Instructions Sheet

IS-92097

REPLACEMENT OF ENGINE BELT GUARD #01-1512 BY #01-1611

Fig. 2

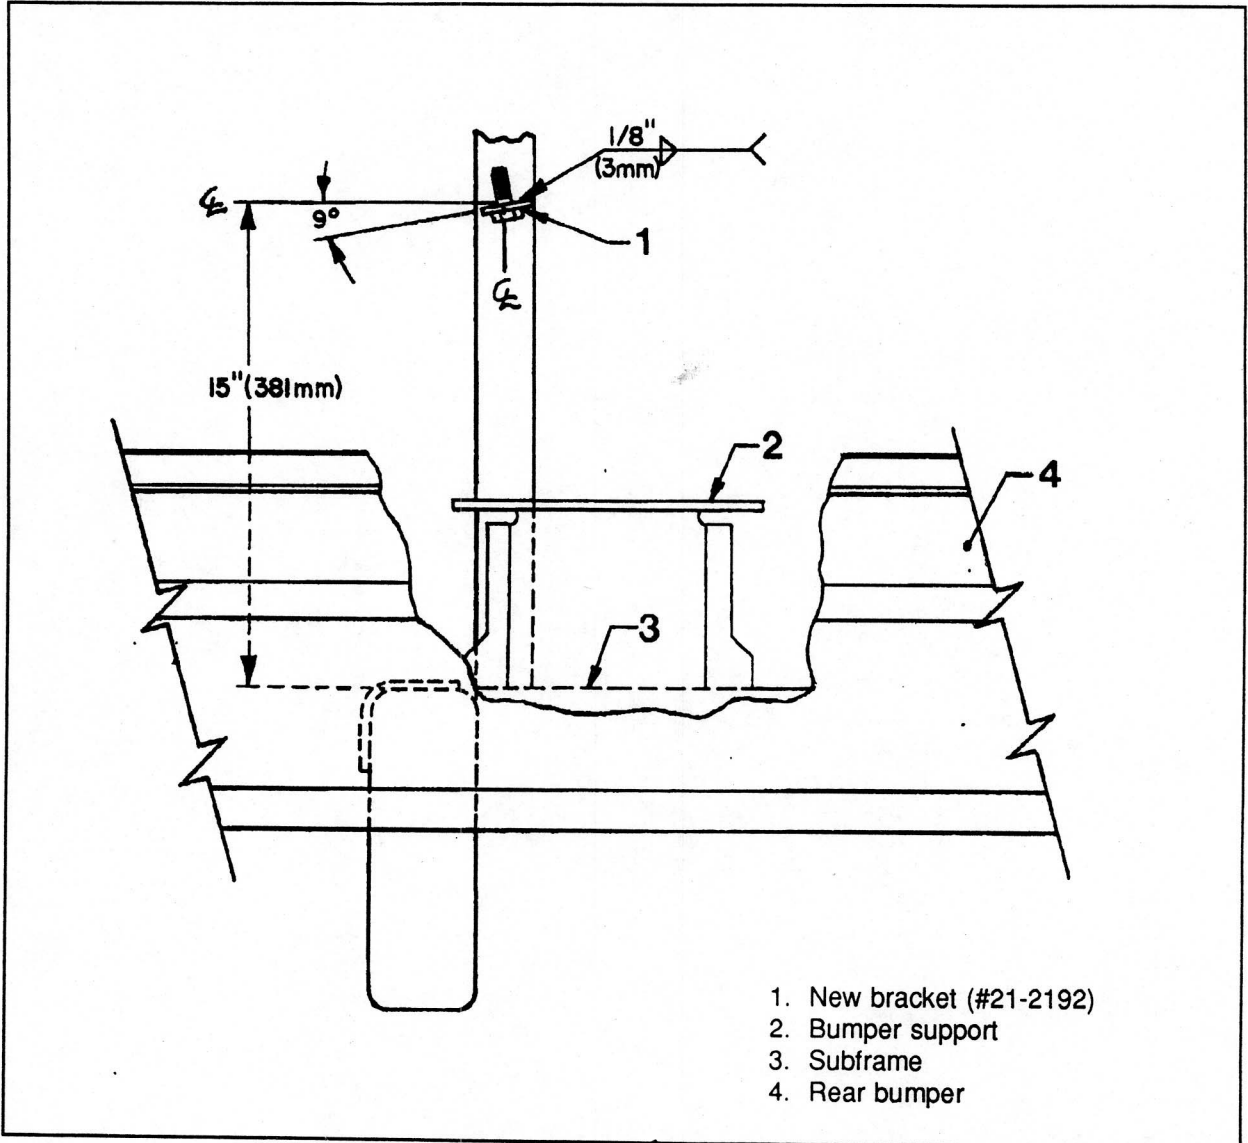
↑
 Bon, mais équipement non disponible
 sans gauge
 Donc à l'avenir mettre ces paramètres
 ↓
